Subject: UniStar Nuclear Energy, NRC Docket No. 52-016
Submittal of Response to Request for Additional Information for the Calvert Cliffs
Nuclear Power Plant, Unit 3
RAI No. 36, Revision 0 – Emergency Planning

Response to RAI No. 36, Revision 0

Emergency Planning

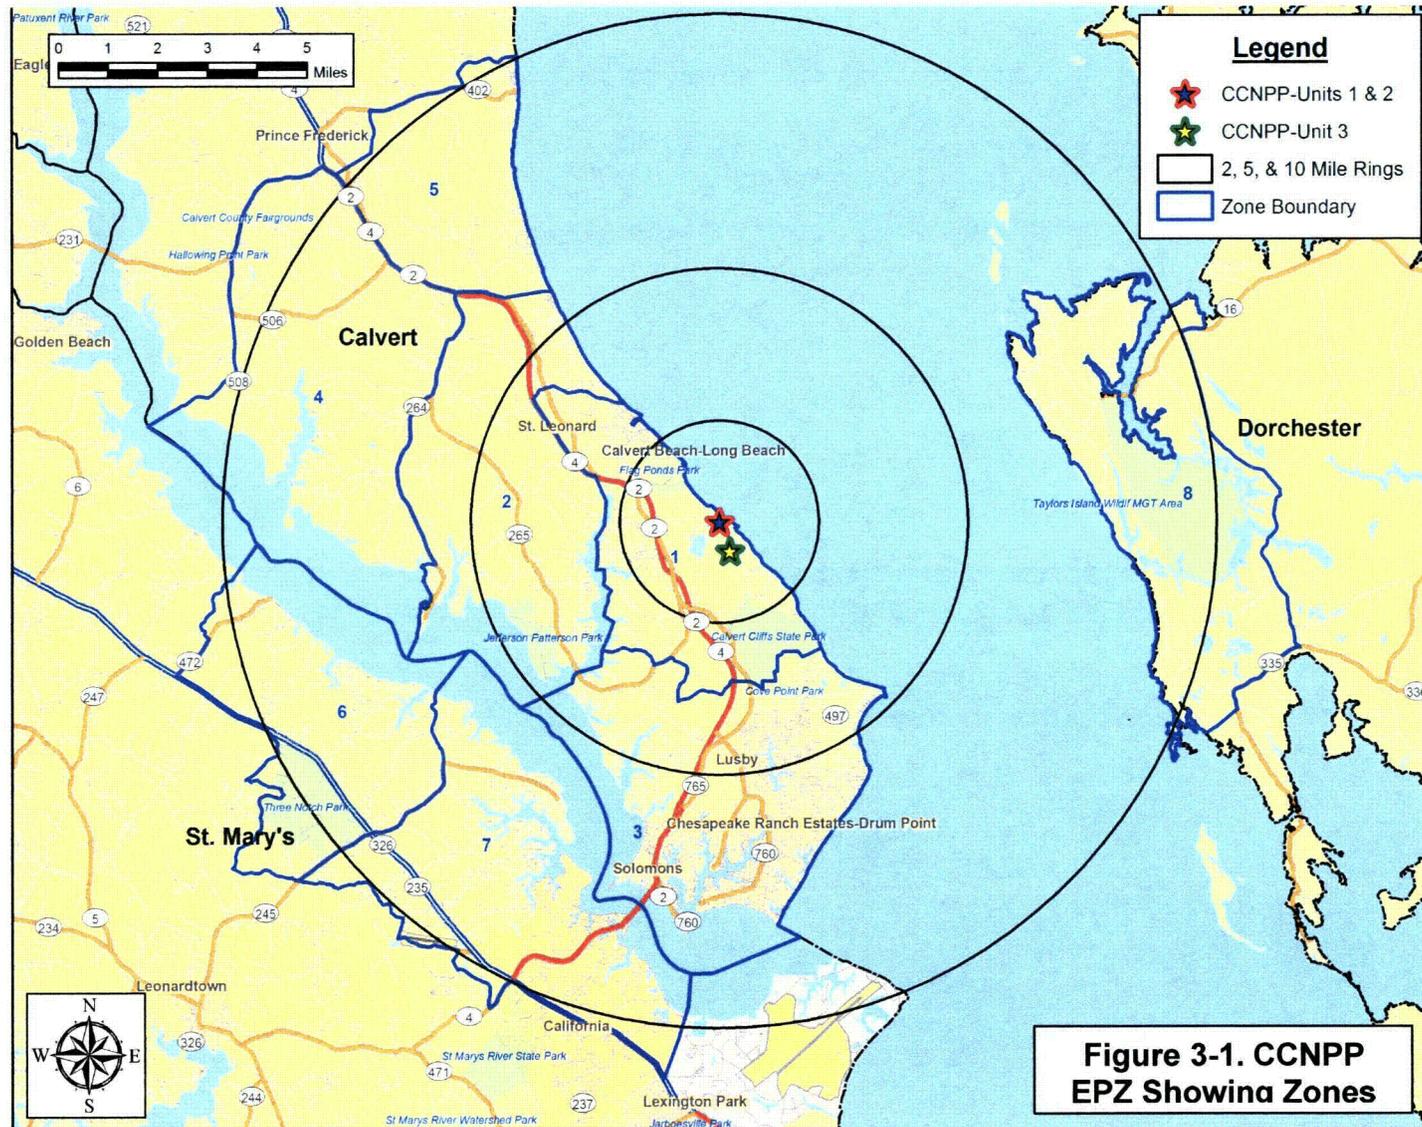
Figure 2-1, "Site Vicinity Protective Action Zones and Reception Centers Plume Exposure Pathway EPZ," (Page 2-12) provides a vicinity map of the Plume Exposure Pathway Emergency Planning Zone (EPZ) as of August 2002. Surrounding communities, political boundaries, and the location of the new unit are not identified. Provide a map that includes any information that may update the 2002 map in the ETE. This map should clearly define surrounding communities, political boundaries, and the location of the new unit.

- Figure 3-1: The eight Protective Action Zones that in aggregate form the CCNPP EPZ. The CCNPP symbol identified on the map in the report is the midpoint of the coordinates for CCNPP Units 1 and 2. The attached map also identifies the proposed coordinates of CCNPP Unit 3; this map will replace Figure 3-1 in a future revision of the ETE report. County boundaries and major communities are identified in the map.

Figure 3-1 of the ETE report (Enclosure 2) will be replaced with the attached figure in a future COLA revision.

Figure 7-3. Congestion Patterns at 1½ Hours after the Evacuation Advisory – Scenario 1, Full EPZ

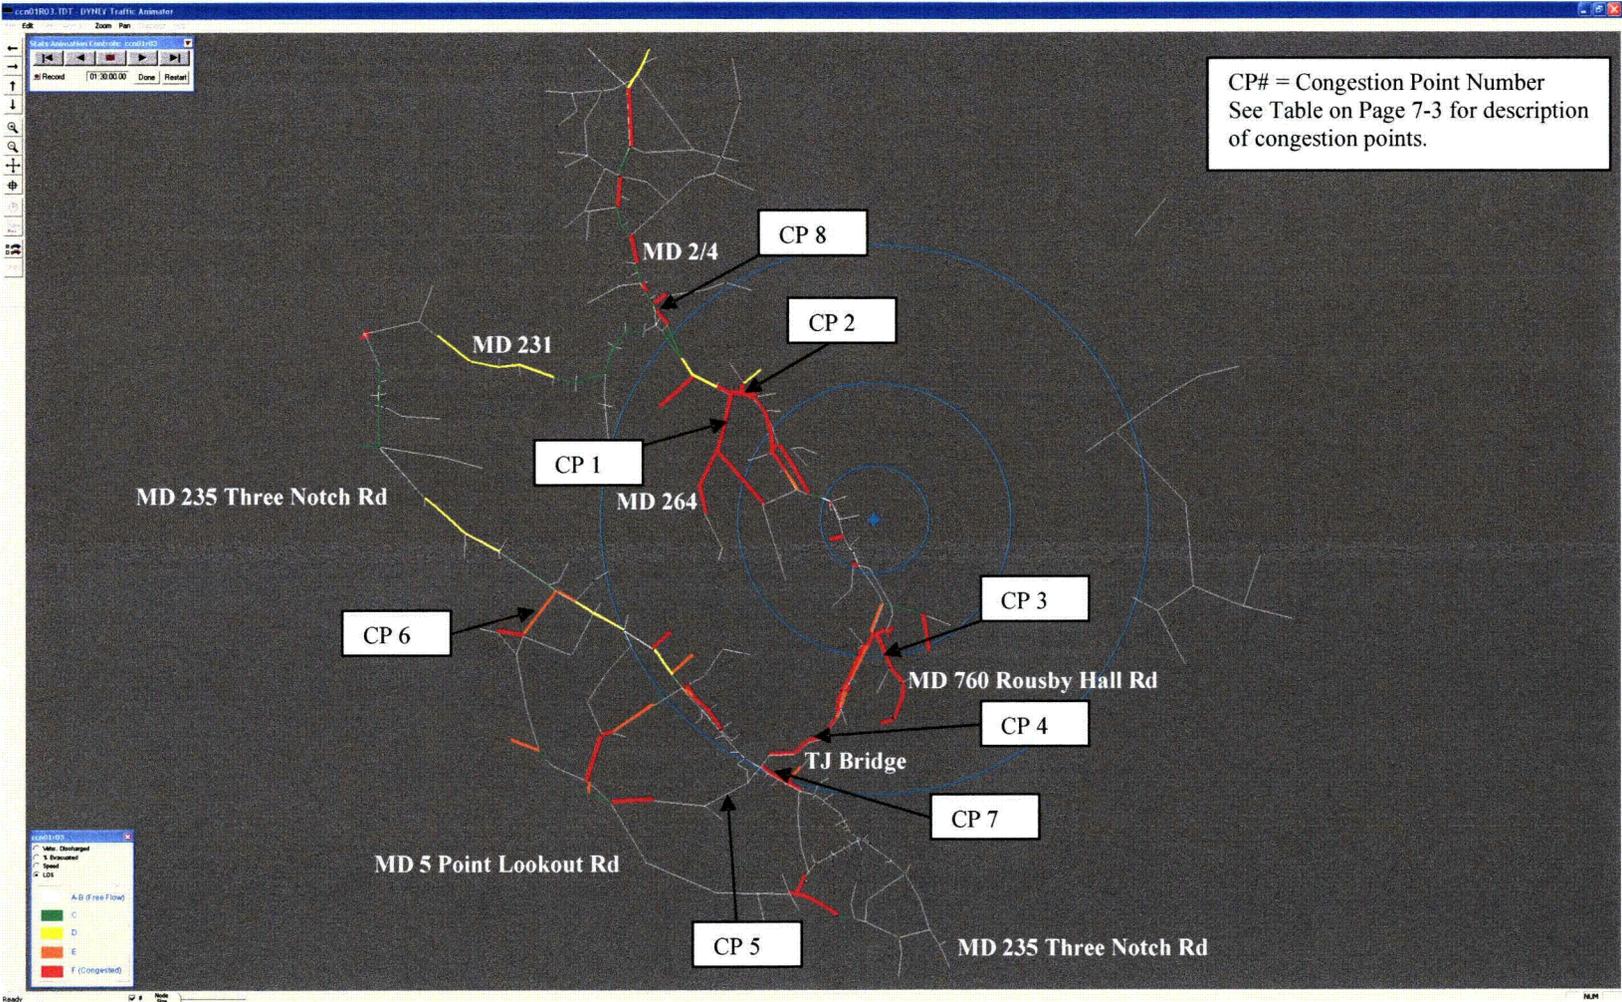
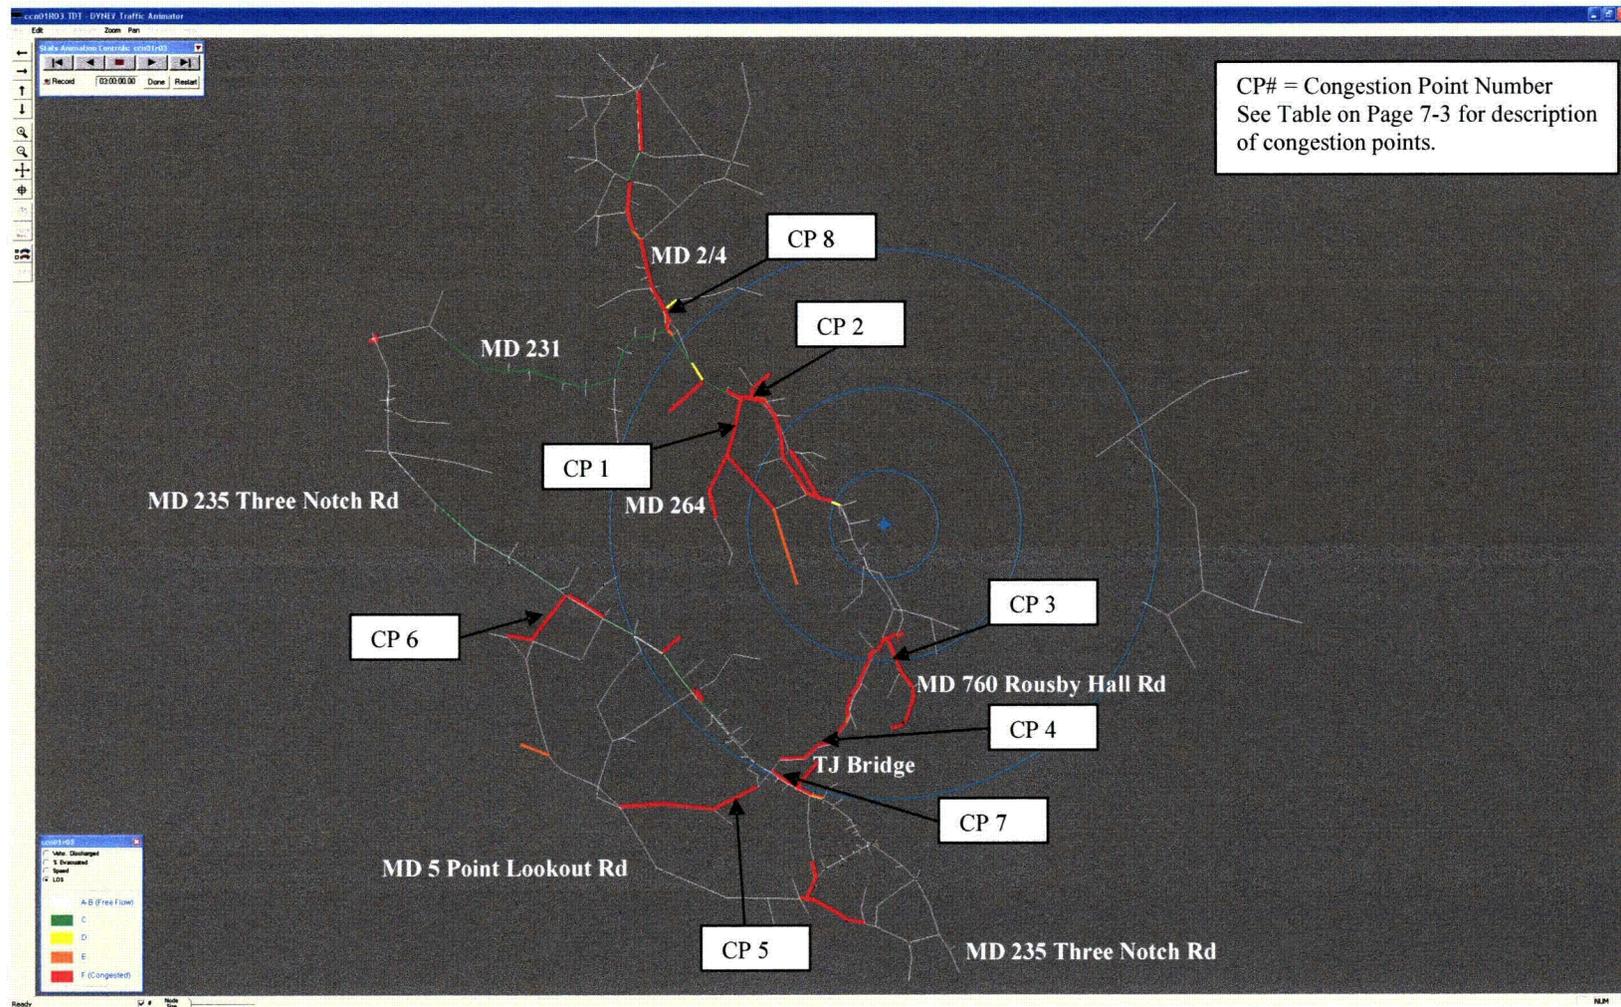
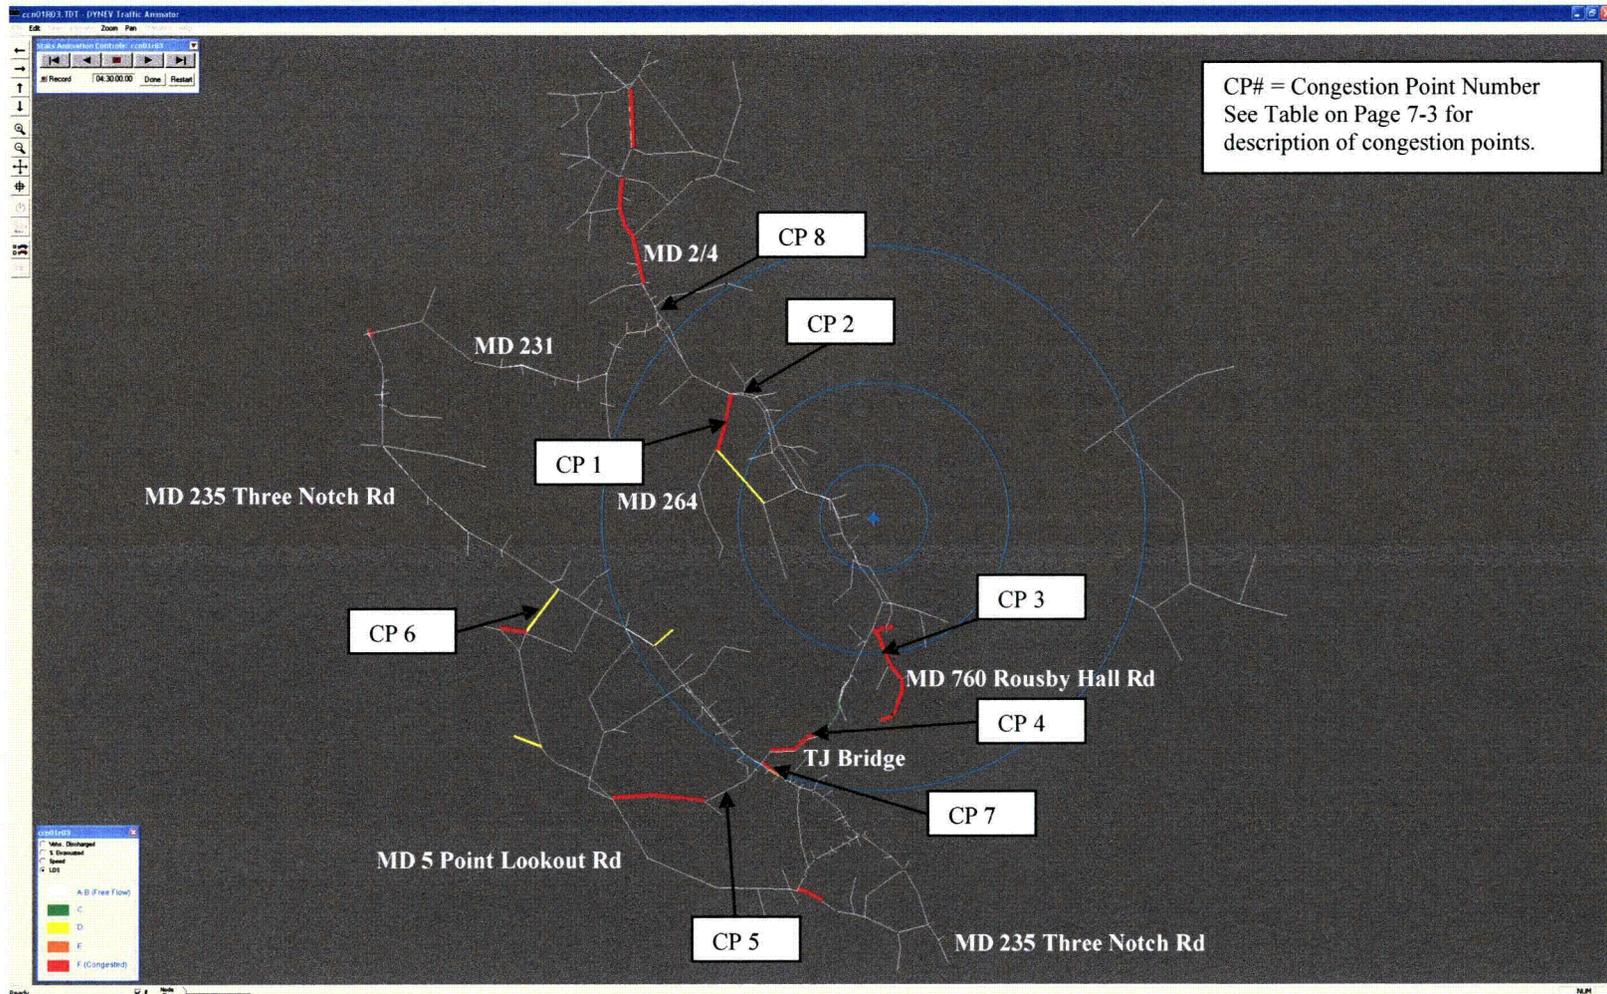
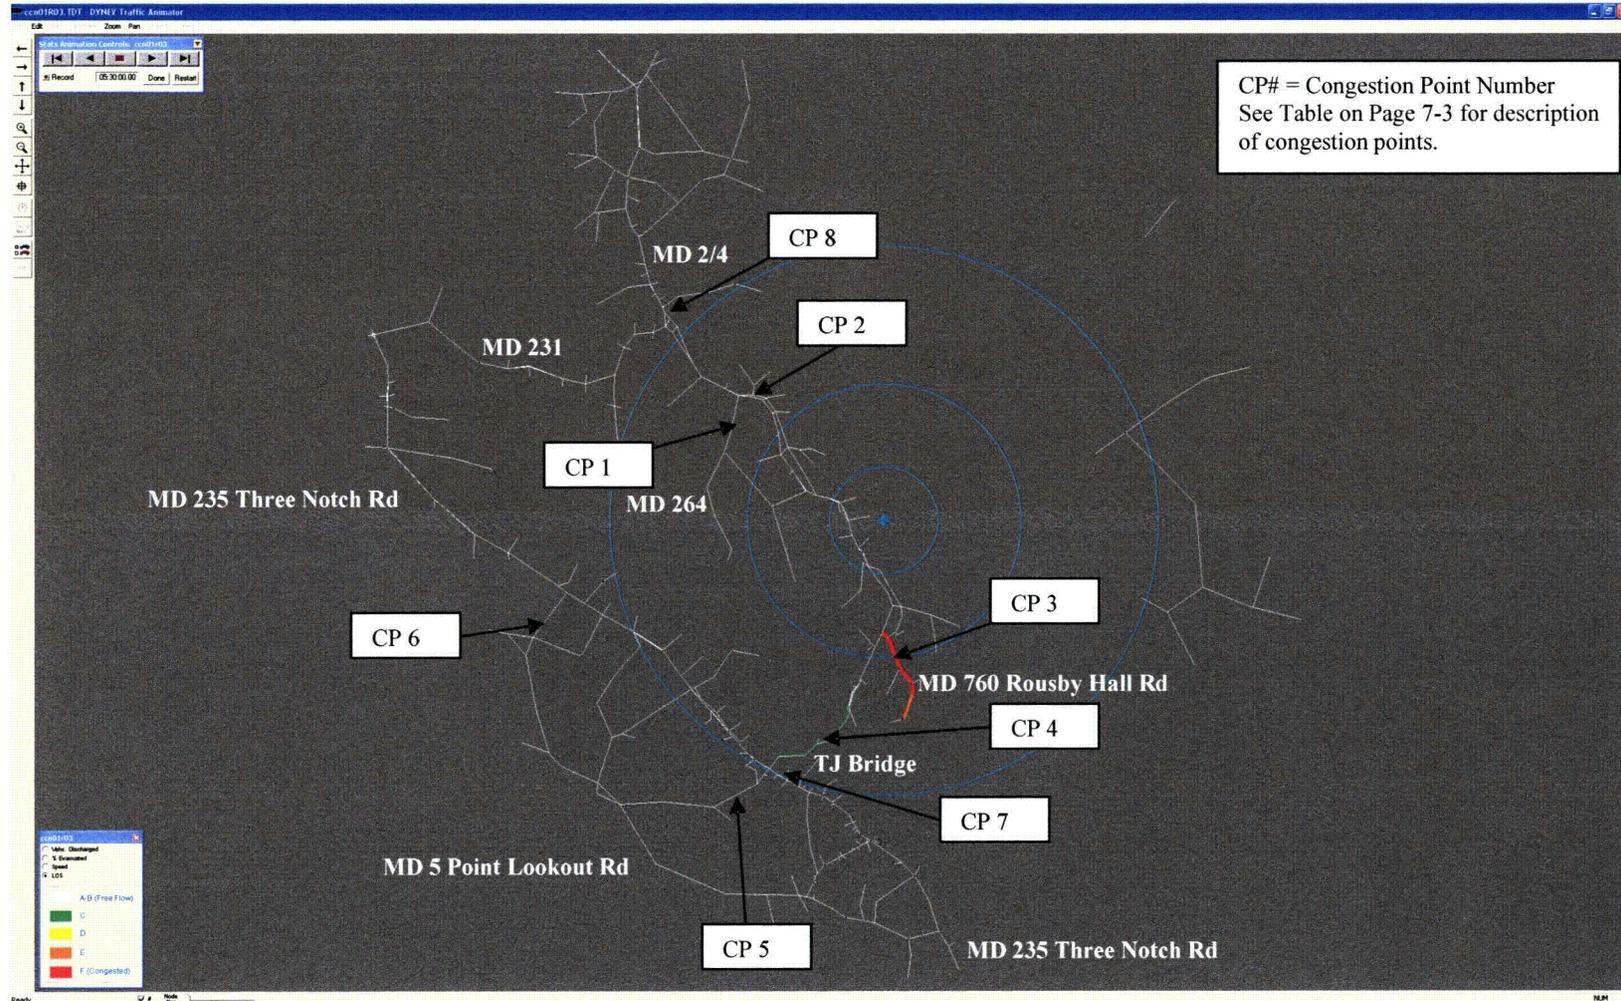
D. Figure 7-1, "Recommended Traffic control," (page 7-3) points out an area of congestion on the Thomas Johnson Bridge at the South of the plant. According to the MD 4 - Thomas Johnson Memorial Bridge Planning Study^[1], (pages 1-7) congestion on Thomas Johnson Memorial Bridge is problematic. All intersections have a failing Level of Service (LOS) in both the AM and PM peak hours. This information agrees with the findings in, "St. Mary's County Transportation Plan^[2]," which identifies a need to widen Maryland Route 4 and add an additional span to the Thomas Johnson Bridge to accommodate existing conditions and anticipated growth. The current situation with traffic congestion on Maryland Route 4 and the Thomas Johnson Bridge is not addressed in the ETE. Provide additional information on potential traffic congestion associated with the Thomas Johnson Bridge and Maryland Route 4 during evacuation scenarios.

D. Section 7.2 of the 2008 ETE report discusses the patterns of traffic congestion during evacuation. The text indicates that there is pronounced congestion southbound on Maryland Route 2/4, especially in the area of the Thomas Johnson Bridge. Figures 7-3 through 7-6 provide screen captures from EVAN (Evacuation Animator) which show the level of service (LOS) on all links in the analysis network at that time. The links are color coded according to LOS, with those links experiencing LOS F (congested) colored red and those experiencing LOS A (free-flow) colored white. As Figure 7-5 indicates, congestion on the Thomas Johnson Bridge persists until 4½ hours after the advisory to evacuate, while congestion on Rousby Hall Road extends to almost 6 hours.

Based on guidance provided in NUREG-0654, revised versions of Figure 7-3 through 7-6 (attached to this response) were created, which identify the major roads in the analysis network and the major congestion points. The attached table summarizes the delay (minutes/vehicle) at each of the congestion points over the 10-minute period preceding the indicated elapsed time from the advisory to evacuate. This table and the revised Figure 7-3 will be included in Section 7 of a future revision of the ETE report.
